GENERAL INFORMATION

Applicant:	Lifespace Communities Inc. DBA Friendship Village of Bloomington
Location:	8100 Highwood Drive
Request:	Major Revision to Final Development Plans to modify the size and footprint of an approved but not yet constructed five-story, independent senior living building from 98 units to 93 units while preserving existing townhomes.
Existing Land Use:	Office (vacant), residential care facility, multiple-family and two-family (senior living) dwellings; zoned RM-24(PD) Multiple-Family Residential (Planned Development)
Surrounding Land Use and Zoning:	North – Freeway I-494 right-of-way South – Tierney's Woods Park; zoned SC East – Single-family residential; zoned R-1(PD) West – Trunk Highway 169 right-of-way
Comprehensive Plan Designation:	High Density Residential

PROPOSAL

Figure 1 – Residential Building Footprint Comparison

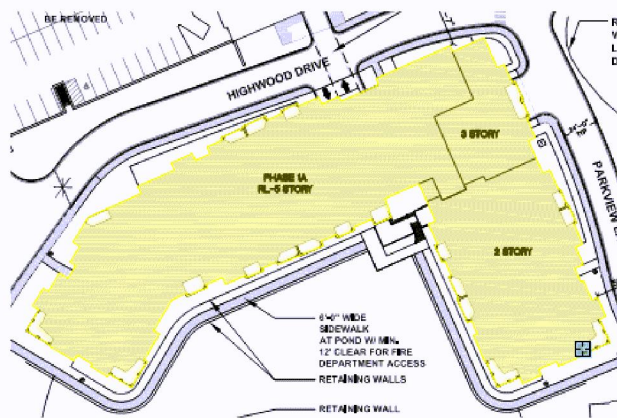
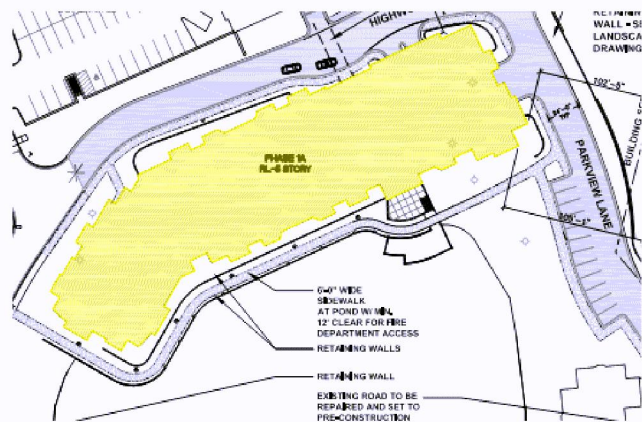
The senior living building footprint would be reduced from approximately 44,380 square feet (including balcony areas) to approximately 33,065 square feet, representing a 25.5 percent reduction. Figure 1 compares the approved building footprint against the revised building footprint presented in the subject application. The overall residential building floor area is reduced from 166,922 square feet (excluding garage area) to 156,000 square feet. The building footprint revision removes the eastern wing of the building, which is the two-story portion in closer proximity to the adjacent single-family residential subdivision (Tierney's Woods)

The previously approved residential building is located 50 feet from the single-family residential properties, whereas the revised residential building is located 93.8 feet from the abutting single-family properties. While the building footprint is reduced by 25 percent, the unit count is only reduced by five due to a height increase of a portion of the building (13.4 percent) from three stories to five stories. Table 1 provides a breakdown of the unit quantities and types on each floor of the

Figure 3 – Wetland Impacts Comparison

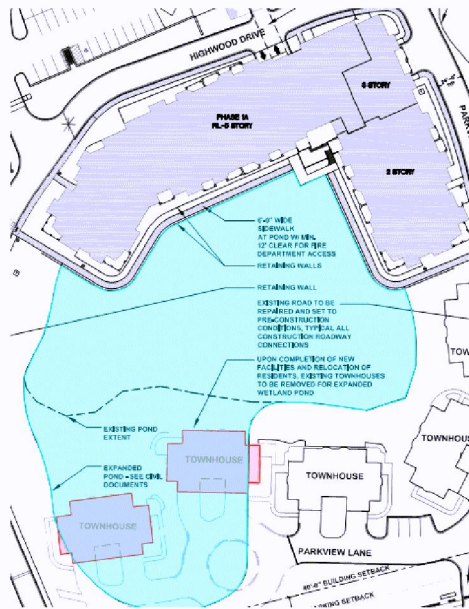
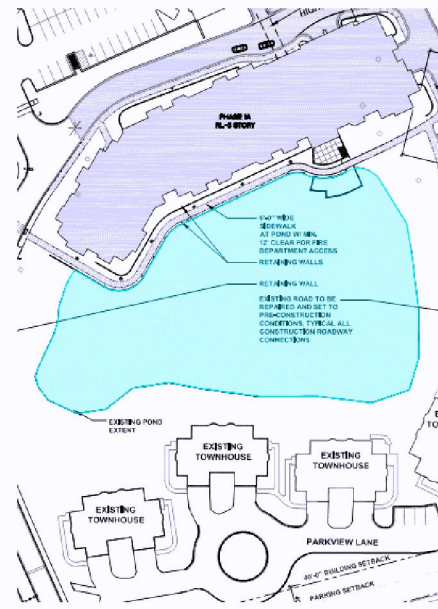
The wetland impacts associated with the revised site plan are less from an overall disturbance and intrusion standpoint. Although, the pond surface area is reduced with the revised site plan. Figure 3 shows a pond comparison between the approved site plan and revised site plan. The existing pond size is 82,621 square feet. The resulting pond size on the approved plan (Case #PL2017-250) is 77,092 square feet (93.3 percent of original size), whereas the revised site plan pond size is 60,506 square feet (73.2 percent of original size). The revised site plan retains four townhome units, whereas the approved plan includes the removal of these townhomes for the pond expansion. As part of the 2018 approvals, a Wetland Replacement Plan was approved which included the procurement of wetland bank credits under the procedures established in the Wetland Conservation Act (WCA). The wetland credits have been obtained by the applicant.

The proposed changes will reduce the wetland impacts due to the reduced building footprint, from the previously approved 27,969 square feet to 22,115 square feet. The original wetland impacts were approved by the City Council on February 5, 2018, meeting the criteria of the Wetland Conservation Act and as recommended by the Technical Evaluation Panel. Wetland credits were purchased at a 2:1 ratio, resulting in an excess credits of 11,708 square feet that the applicant can sell or bank. The project remains compliant with the Wetland Conservation Act (WCA).

Figure 4 – New Surface Parking Areas

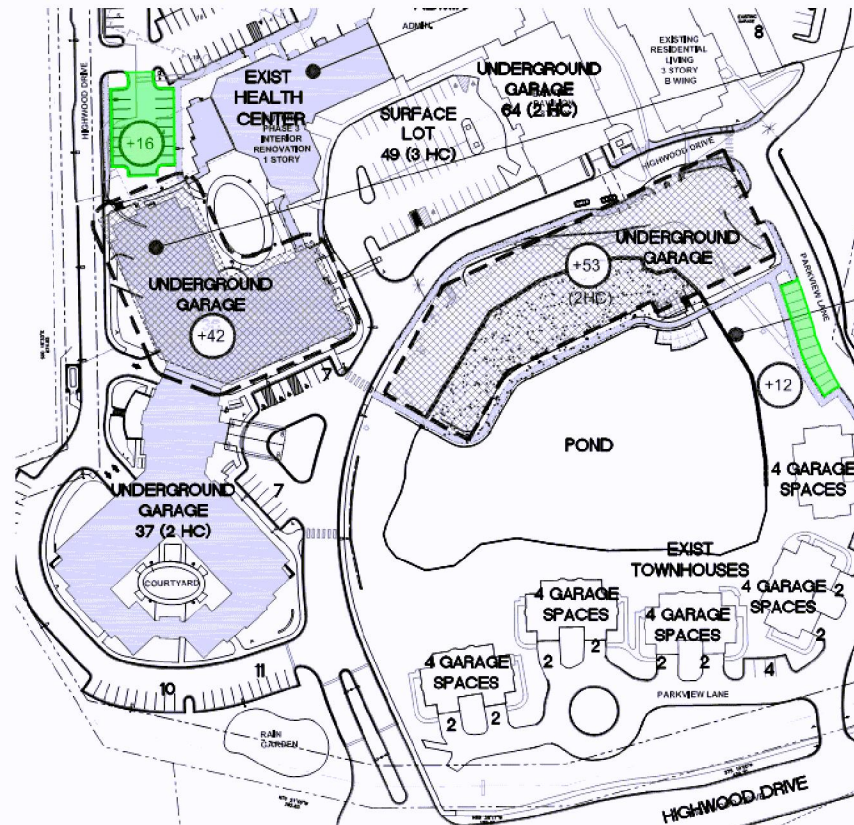
Two additional surface parking areas are proposed as part of the revised site plan. Figure 4 highlights the location of the new parking areas, totaling 28 surface parking stalls. 22 parking stalls located along the western side boundary along Trunk Highway 169 right-of-way are proposed to be

removed from the approved site plan, and additional parking stalls are added in a few locations through utilizing additional available land area. The result of the proposed parking changes increases surface parking from 284 to 302 spaces, decreases underground garage parking from 233 to 230 spaces, and increases total site parking from 226 to 233 spaces.
